DOE-0170-06

**TRANSMITTAL OF THE ADDENDUM TO THE CERTIFICATION DESIGN LETTER  
AND CERTIFICATION PROJECT SPECIFIC PLAN FOR AREA 4B - PART ONE**

V/F: 20810-PSP-0008-08

V/F: 20810-PSP-0008-13

FIGURE 1. MAXIMUM EXTENT OF STORM WATER OVERFLOW IN CERTIFIED AREAS

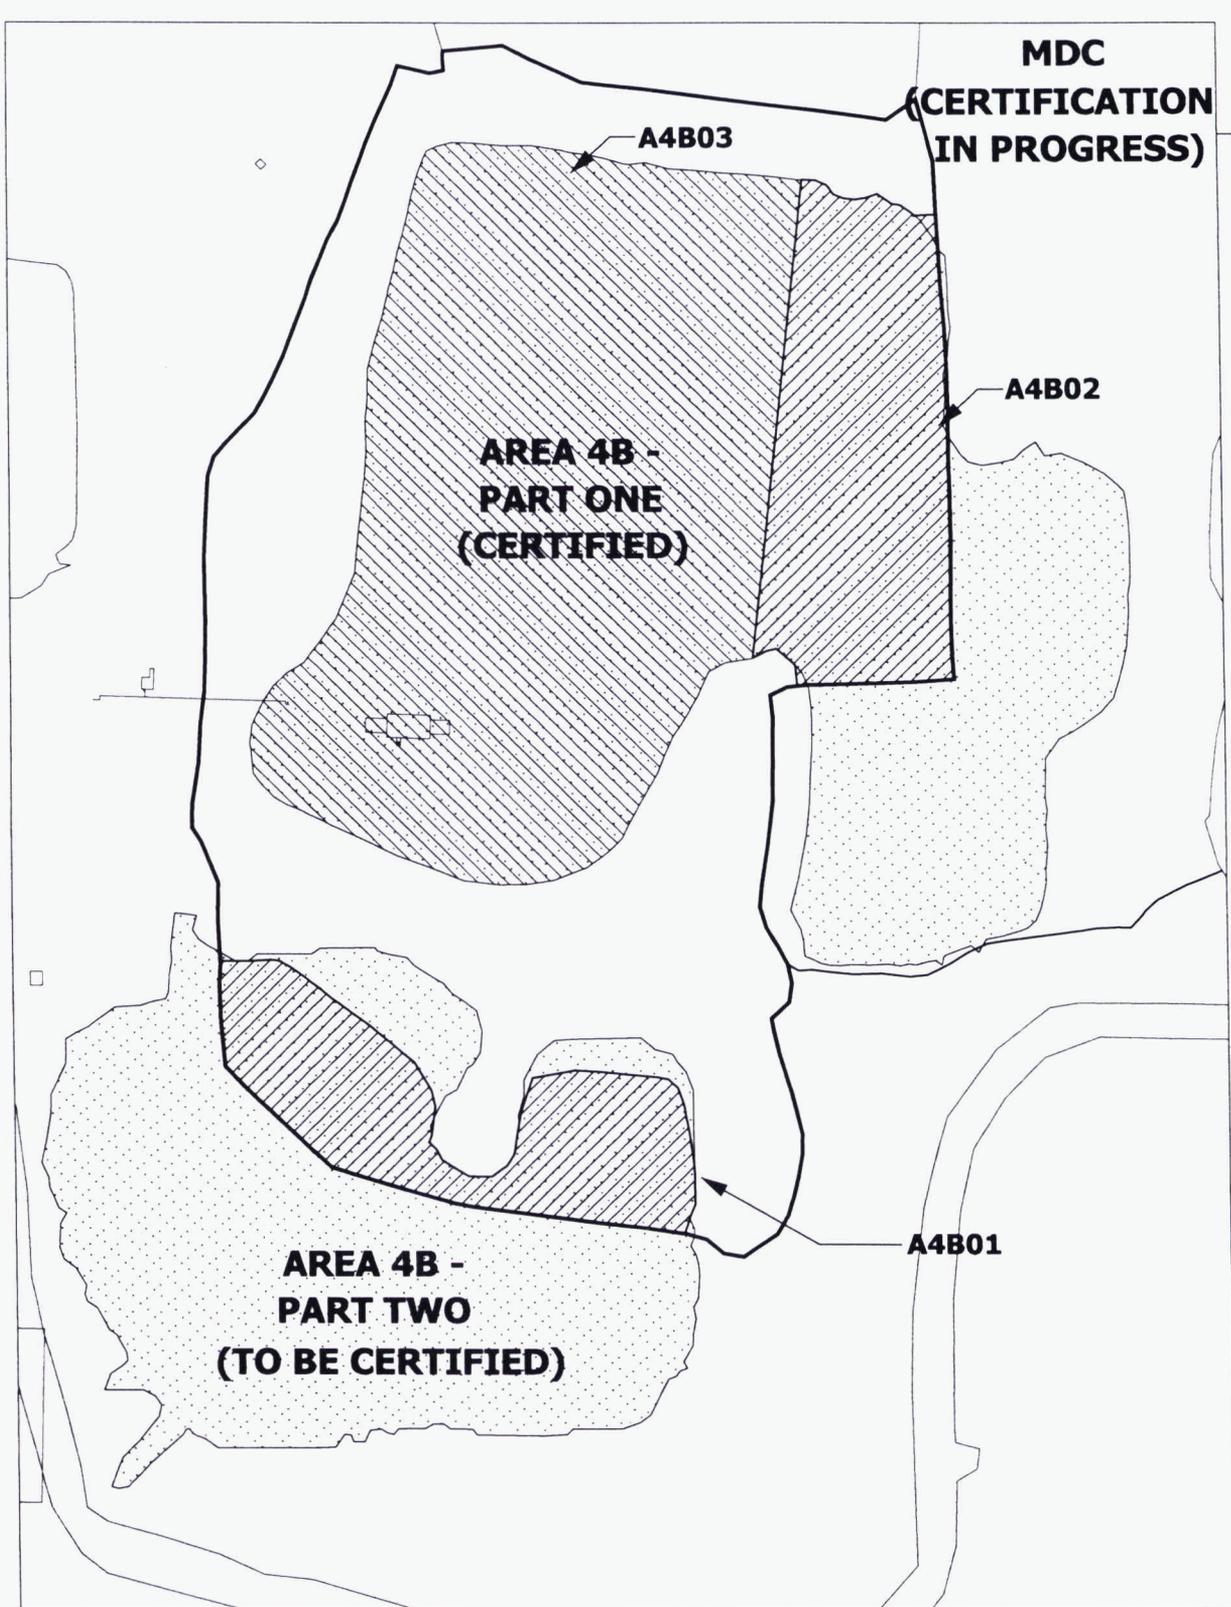
This Variance/Field Change Notice (V/FCN) documents the addition of one certification unit (CU), consisting of 12 soil sampling locations. These samples are being collected because potentially contaminated storm water runoff from the southern end of the Main Drainage Corridor breached the run-on control berms and ditches of the certified area (see Figure 1). Certification Unit A4B03 overlaps portions of previously sampled locations from the original Area 4B – Part One certification effort (see Figure 2). Re-certification samples shall be collected and analyzed for total uranium (TAL M).

FIGURE 2. CERTIFICATION SAMPLING LOCATIONS FOR CUA4B03

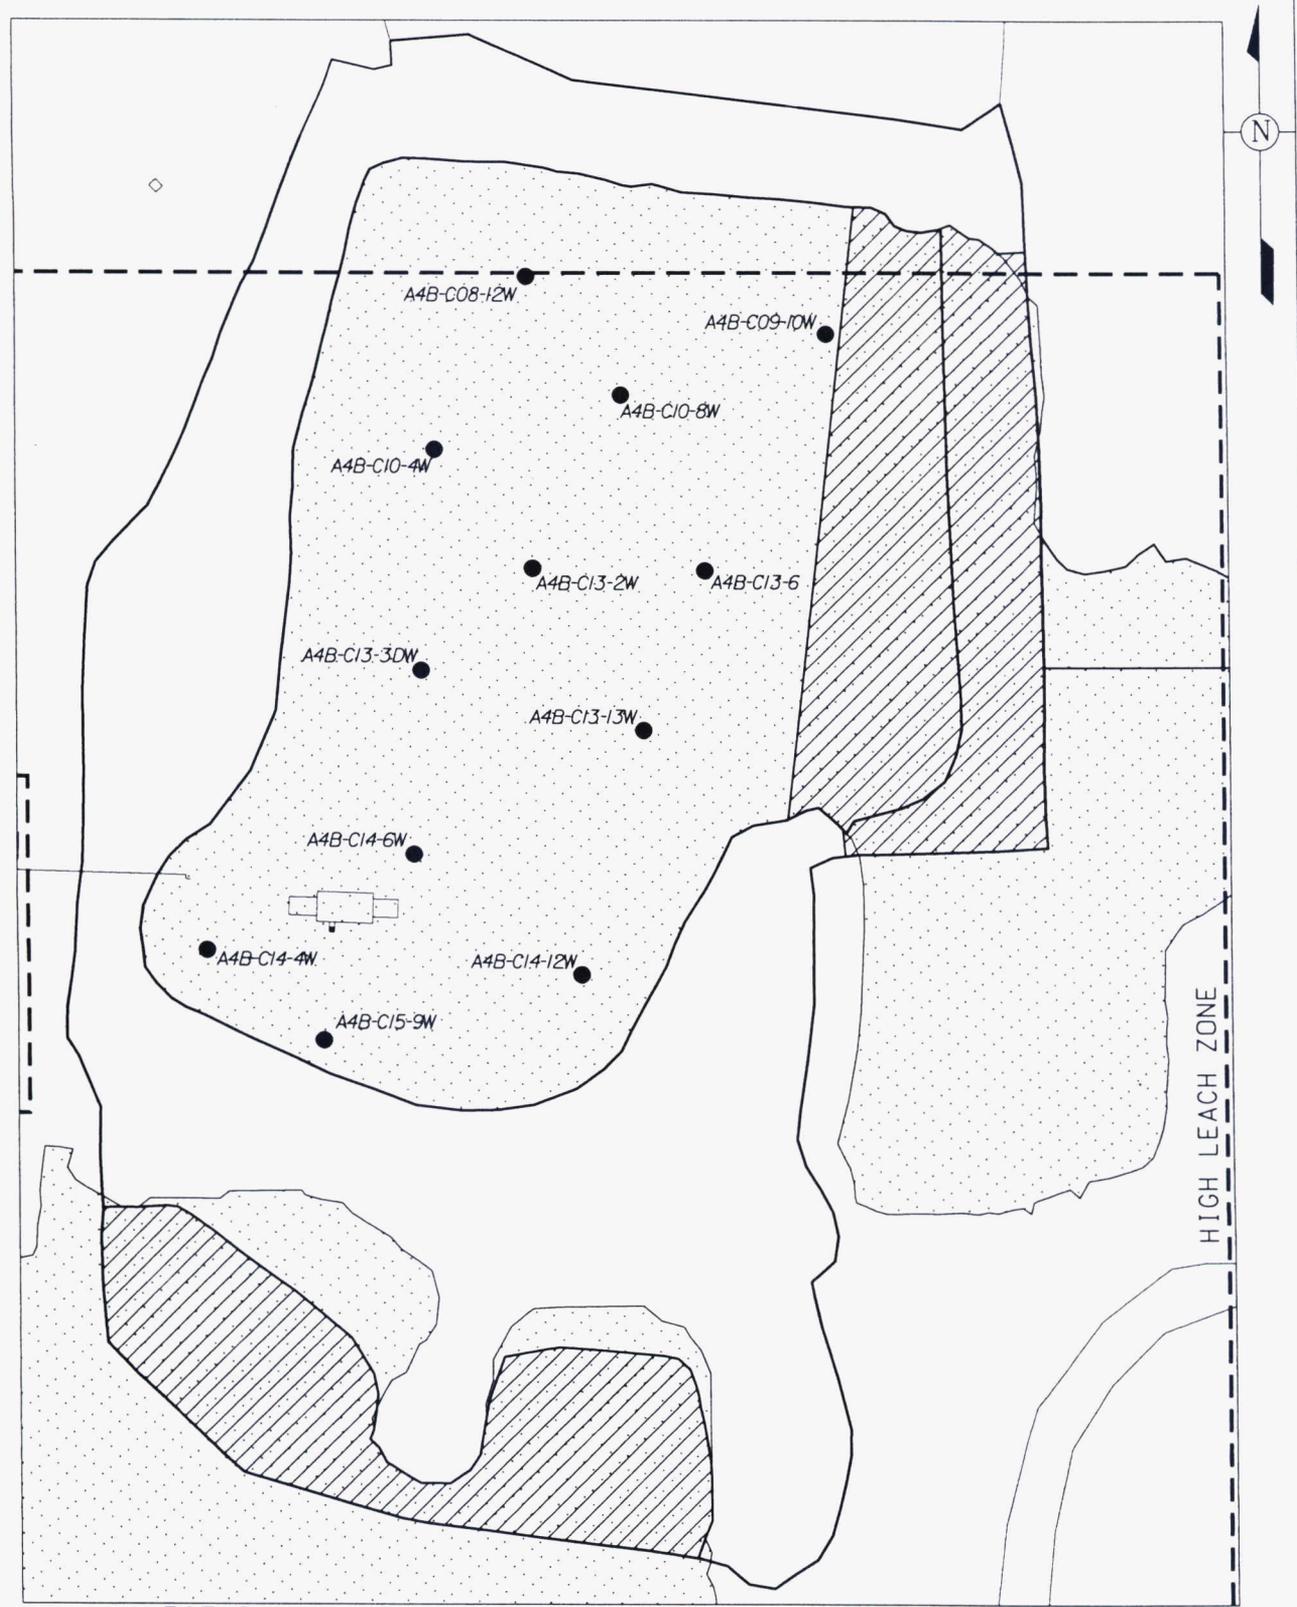
The purpose of this Re-Certification effort is to demonstrate that soil in northern and central portions of Area 4B – Part One has not been impacted from water crossing the certification boundary from southern end of the Main Drainage Corridor and that total uranium still meets the risk-based FRL. The new certification unit has been designed to cover the previously certified area that is currently submerged and has not been resampled. The certification sample locations that fall within the new CU match the locations of the previous certification effort. The data collected under this V/FCN will be compared to the data collected under the original certification effort from these locations. Per Section 4.3 of the PSP, the changes to the PSP will be documented with a V/FCN.
